寄件者: tmylwdpo_pd/PLAND
寄件日期: 2024年10月17日星期四 8:55
收件者: [REDACTED]
副本: [REDACTED]
主旨: 轉寄: A/TM-LTY/477
附件: 回應渠務署提問.pdf; 回應運輸署問題.pdf; 車輛出入模擬圖.pdf; 交通流量評估.pdf; 回應地政處的擬問.pdf

回應地政處的擬問

回應運輸署的擬問

申請臨時公眾停車場事宜

回應第2項

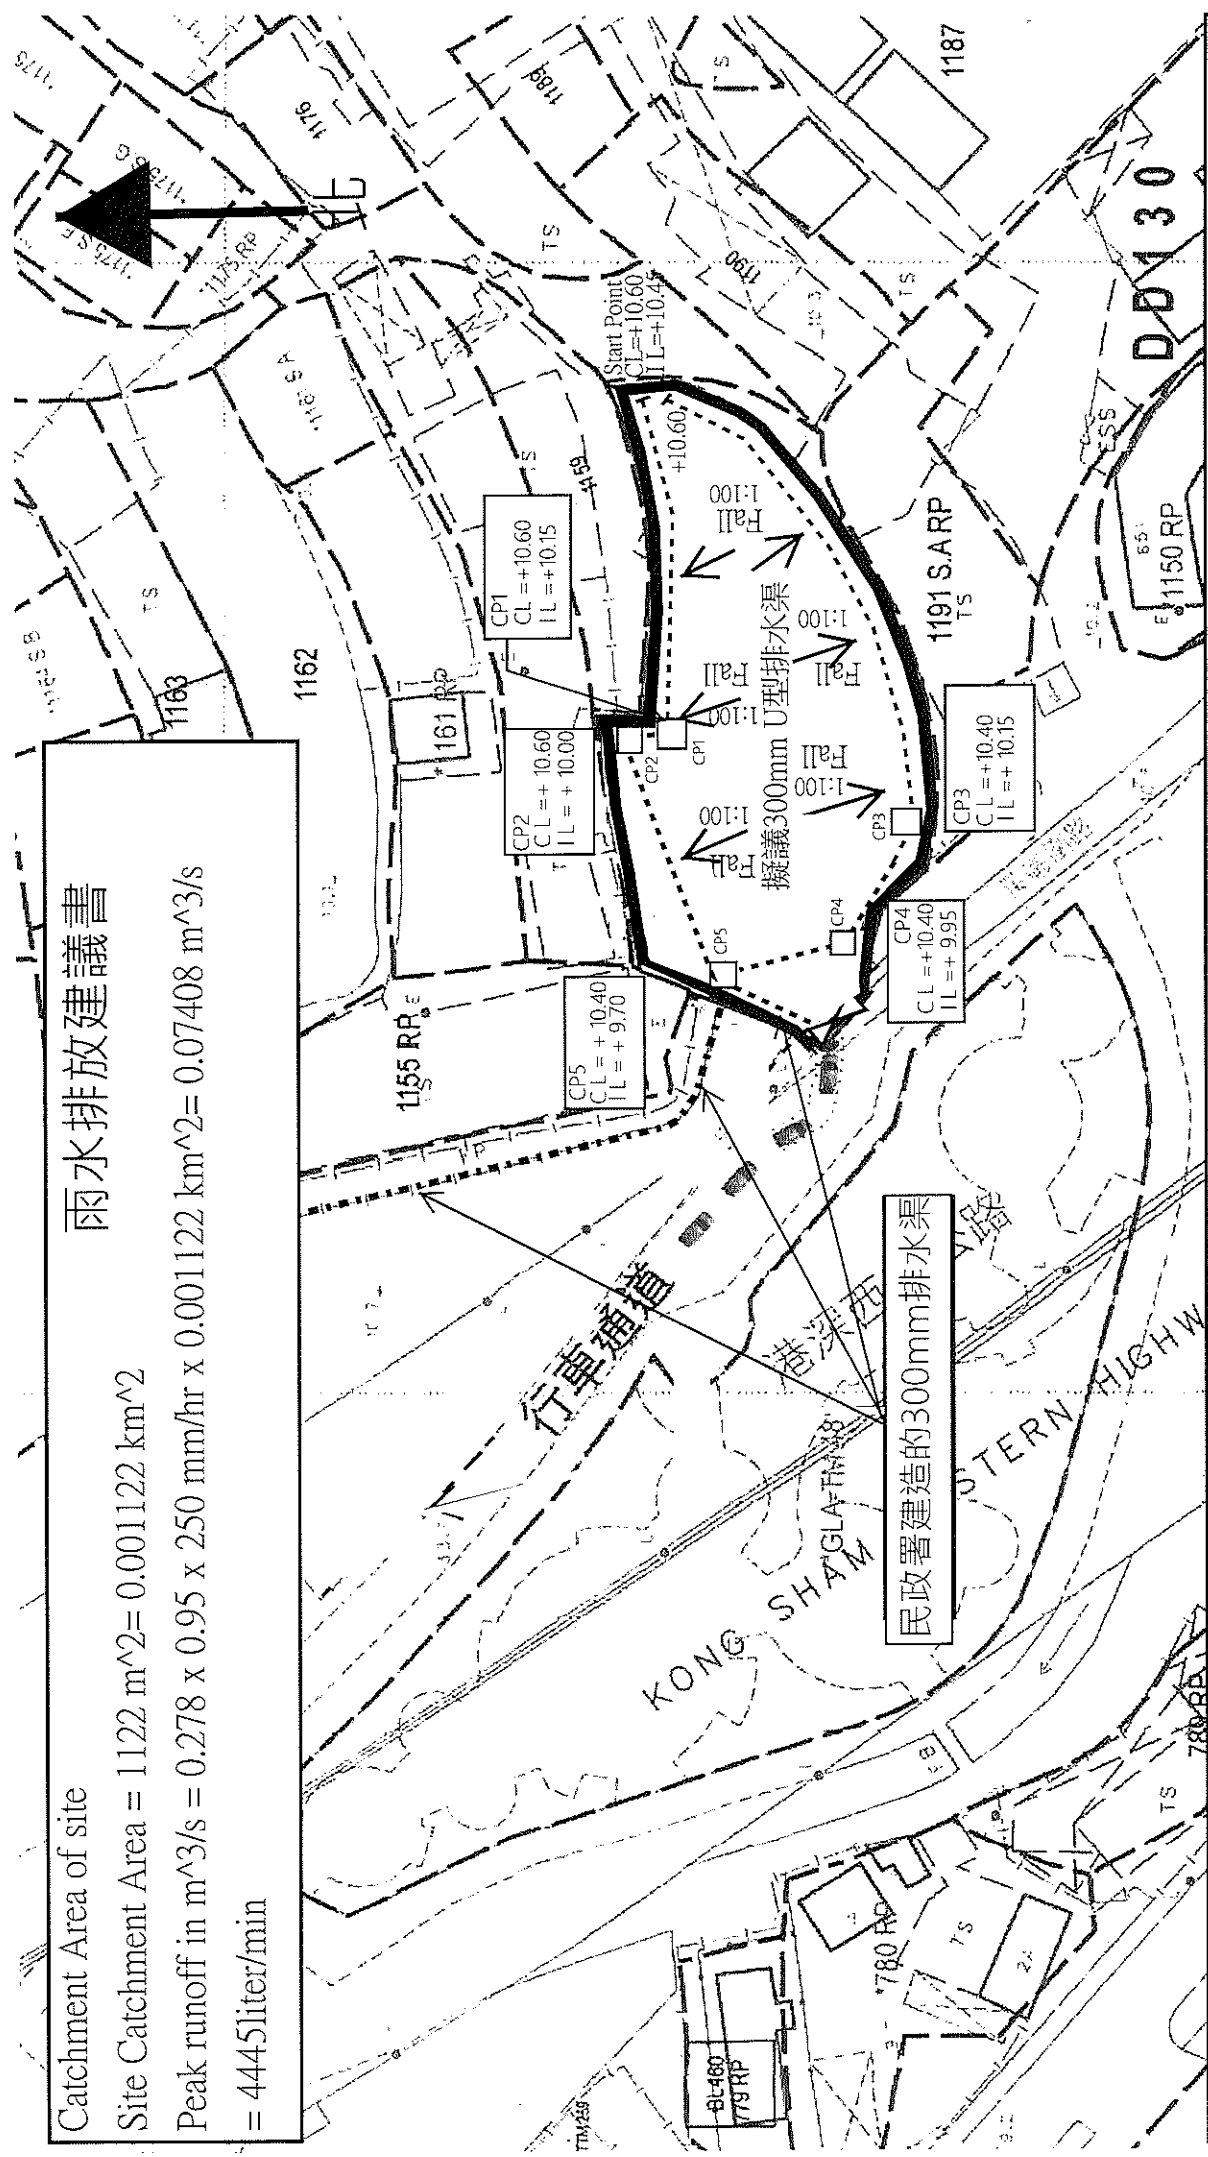
2. The existing u-channel proposed to be connected is not DSD's facilities according to our drainage record plan. DSD noticed that the proposed drainage connections to the downstream areas will run through other private lots. The applicant shall demonstrate that the proposed drainage construction works and the operation of the drainage can be practicably implemented on site. The applicant shall also check and ensure that the proposed drainage works and their downstream drainage systems have the adequate capacity and are in good conditions to accommodate the surface runoff collected from the application site and its upstream catchments. We have the following comments/observations on the captioned submission: - 回應在下方！

i. The proposed u-channel should be installed at the parameter of the site to receive the catchment of the site, or the applicant can show the runoff outside the channel at the northern and western side falling to the proposed u channel.

ii. The existing drainage system to which the proposed drainage connection is to be made is not maintained by this Department, consent from the concerned parties/owners should be obtained for the proposed connections to their drainage system.

場地北面已被1個廠房圍封沒有雨水流經，而西方的地面底於我等場地約20CM，因此毋須作出計算

有關的渠道係由場地業權人向屯門民政署作出申請及由民政署建造給與我等承接的雨水經渠道排走

有關的渠道係由場地業權人向屯門民政署作出申請及由民政署建造給與我等承接的雨水經渠道排走主要為我等場地排水問題而建設的，多年前係有一條雨水渠連接到場地，被鄰近土地業權人非法圍封，經業權人向民政署作出投訴後，民政署才建造有關渠道方便我等排放雨水，

DRAWING TITLE:
(附件1)車輛出入示意圖

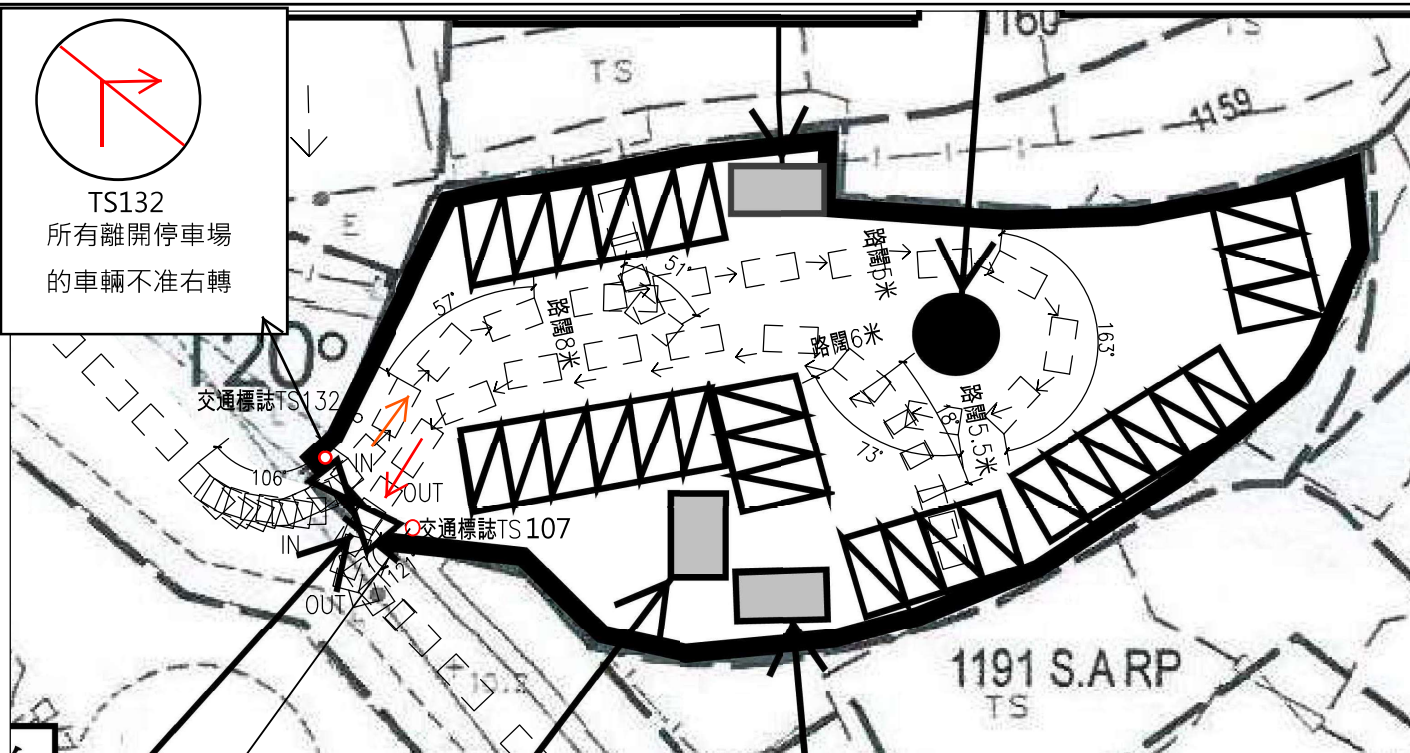
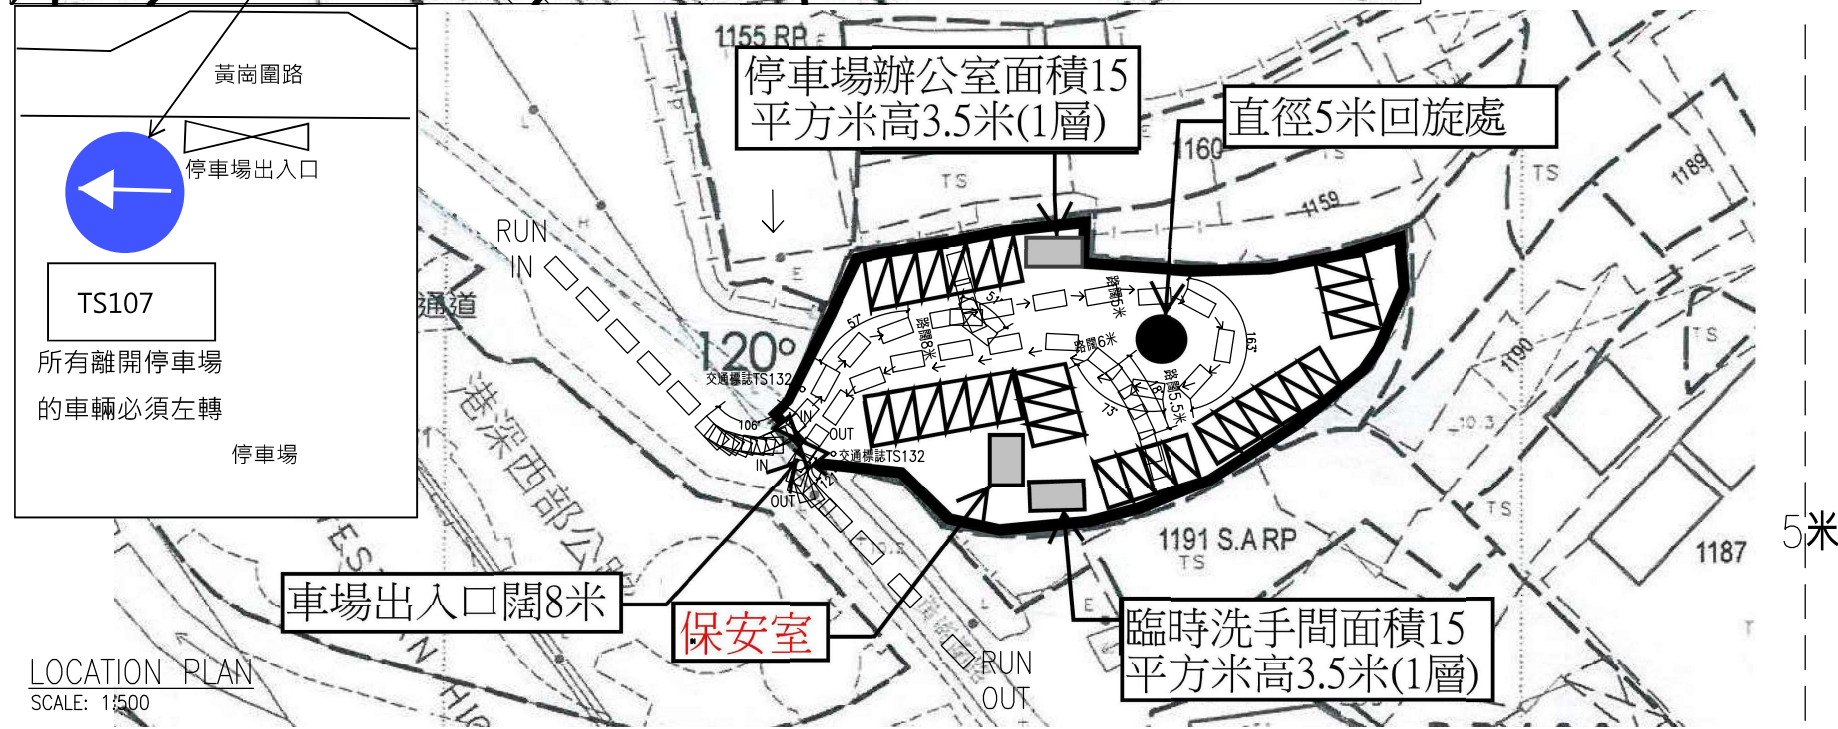
- a. It is noted that a manoeuvring space is reserved in the open area of the proposed site. Please ensure that no queuing and / or waiting of motor vehicles from the site onto Wong Kong Wai Road would occur and no motor vehicles shall be permitted to reverse into and out of the site onto Wong Kong Wai Road.
我等會提交1份車輛進出模擬圖給貴署審議。

- d. Please supplement the swept paths showing the private cars (i) entering the site from and leaving the site to Wong Kong Wai Road; (ii) manoeuvring within the internal access of the site; and (iii) entering and leaving the parking spaces.
我等會提交1份車輛進出模擬圖給貴署審議。

TS132
所有離開停車場
的車輛不准右轉

TS107
所有離開停車場
的車輛必須左轉
